4825 Glenbrook Road N.W.

Feasibility Study

Comments on the Draft-Final Feasibility Study and Proposed Plan
4825 Glenbrook Road
Spring Valley FUDS, Washington DC

**Figure 3
Response Action Areas at
4825 Glenbrook Road**

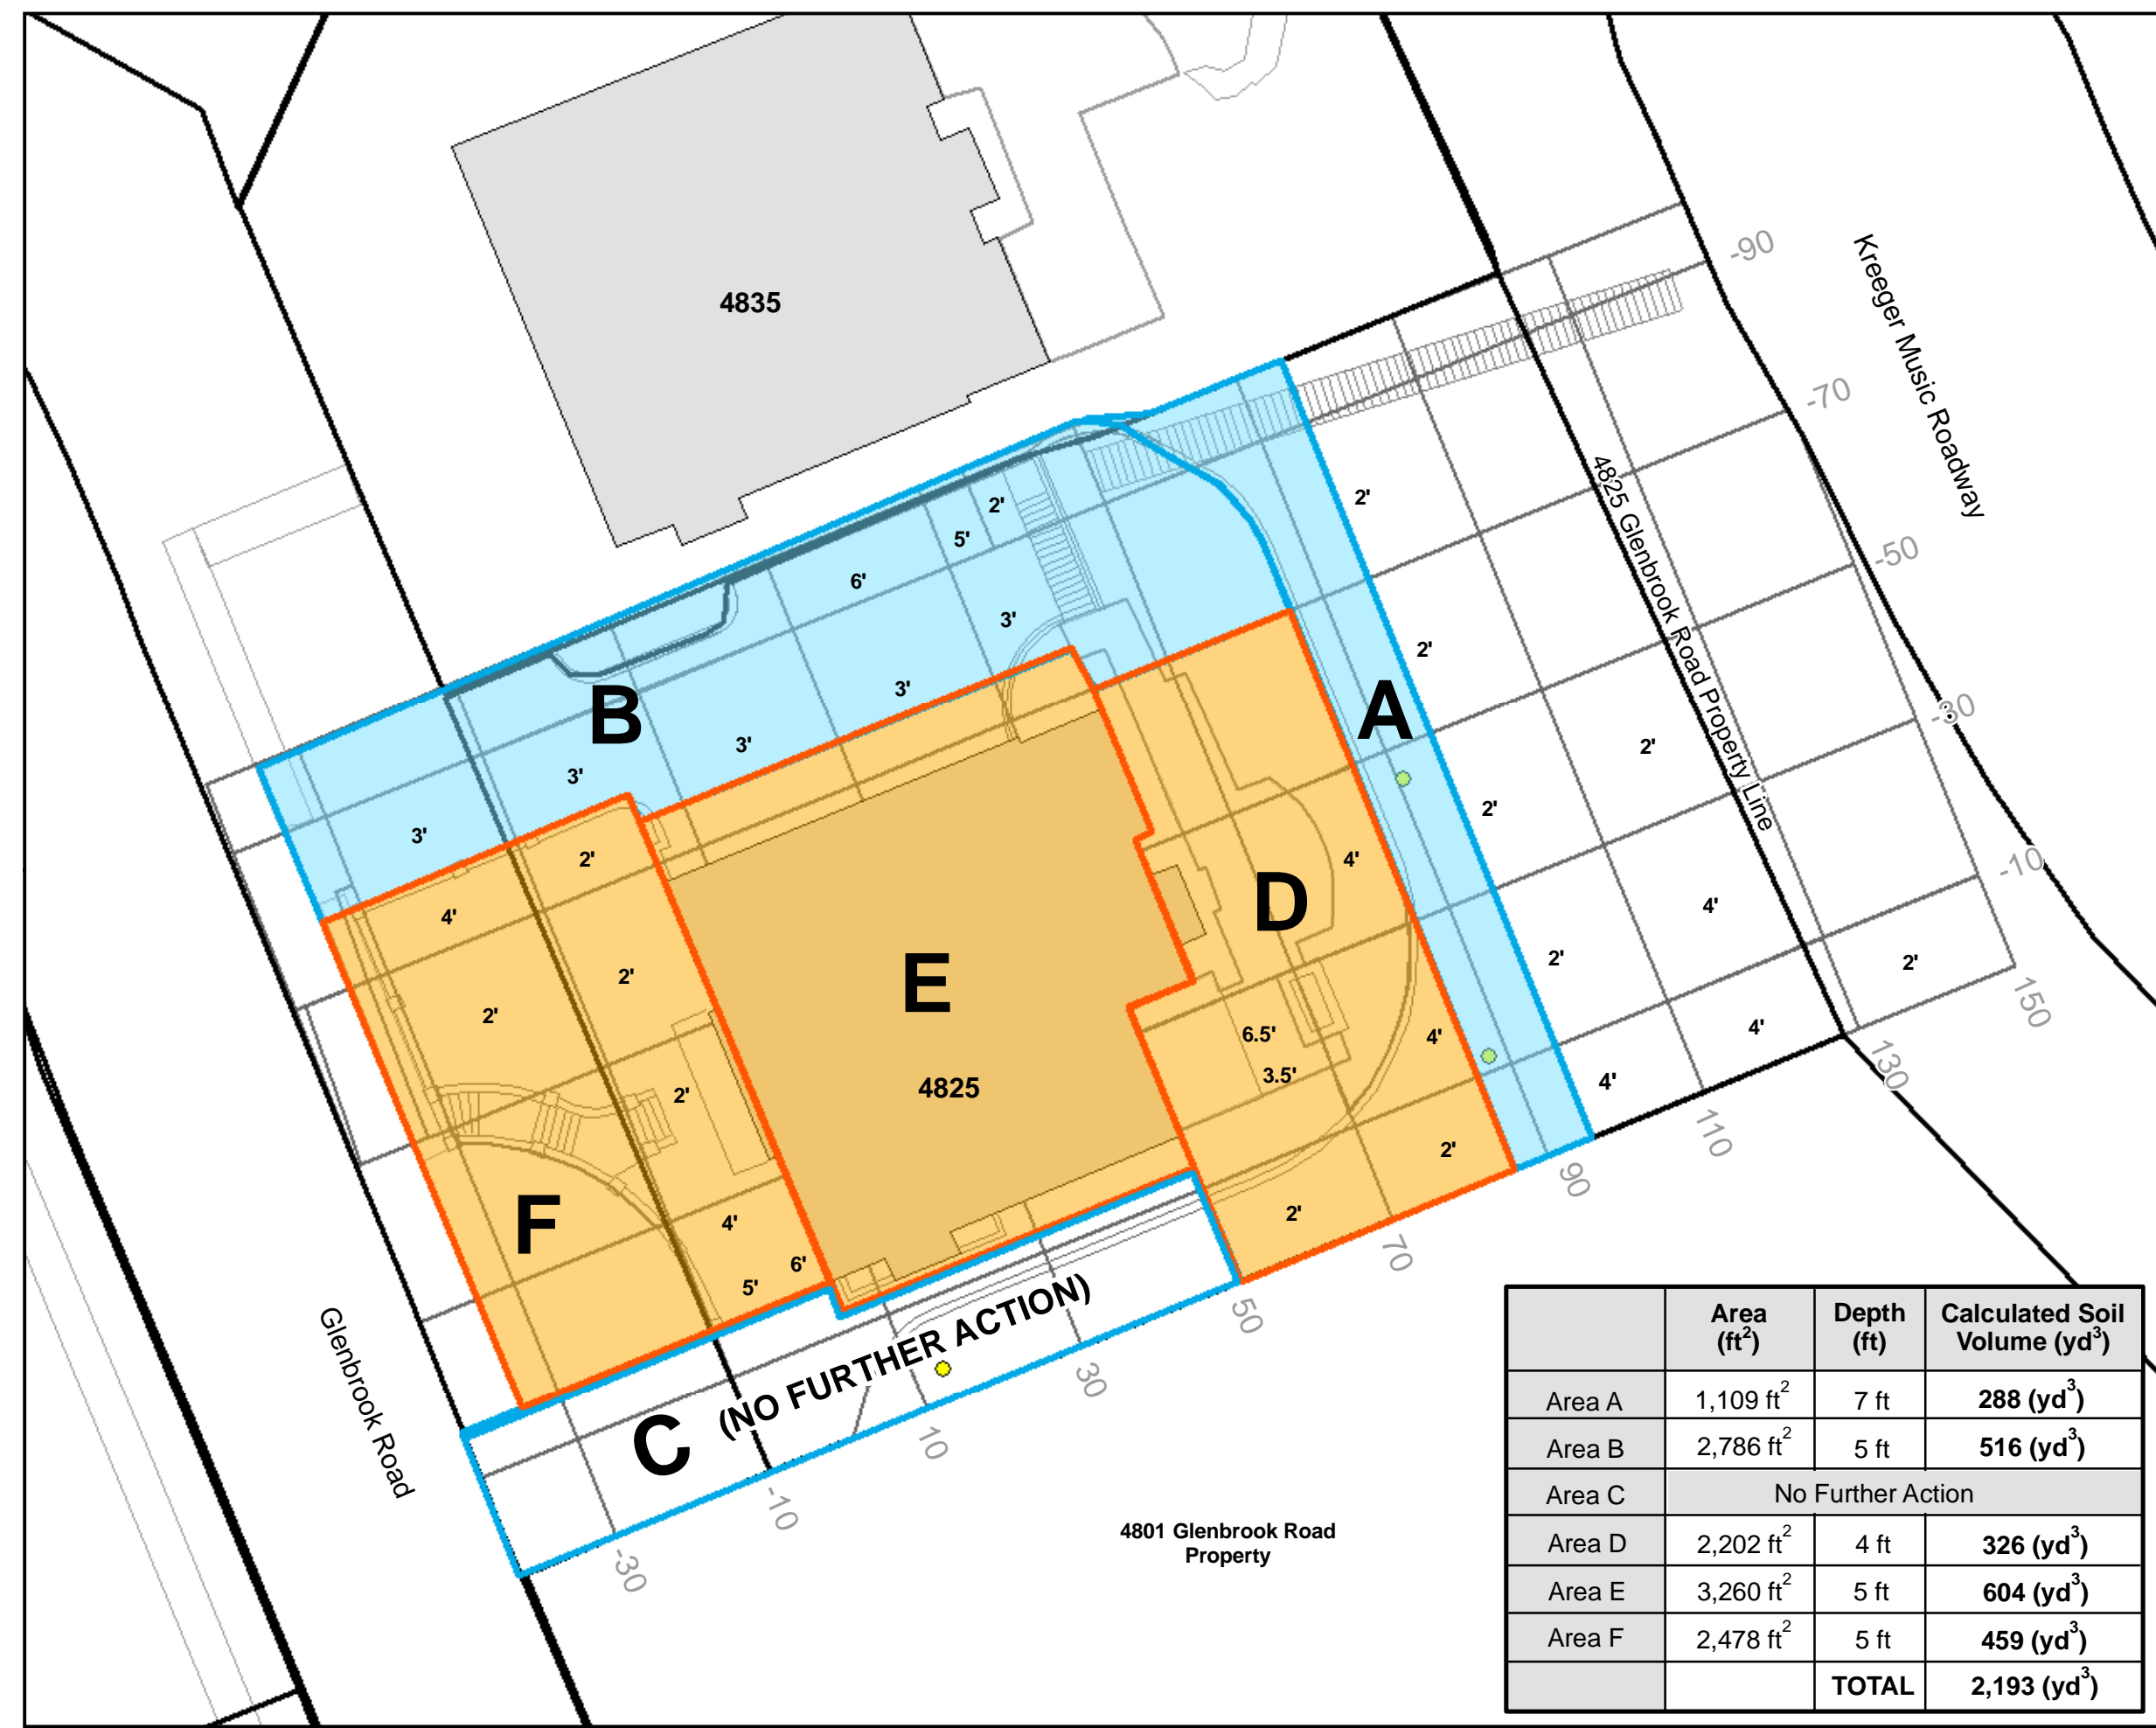
- Section 2.3 refers to the use of low- and high-probability protocols during the remediation process. The designations depend on the likeliness of encountering MEC/CWM in a particular area. A vague statement, “formal determinations will be made through probability assessments developed as part of the remedial action planning,” describes the designation process. If possible, a more detailed description of low- and high-probability designation activities should be included in this section, so that it will assure that the process will be objective, consistent, and adequate.

RESPONSE: Figure 3 is presented as a preliminary indication of which areas will likely end up as high probability and which will be low probability. At the FS stage, the work efforts are insufficiently detailed to state with certainty the exact dimensions and justifications for each area, and therefore, these discussions are presented for planning purposes only. It is during the remedial action planning that USACE will prepare formal probability assessments to be used as the basis of completing the work.
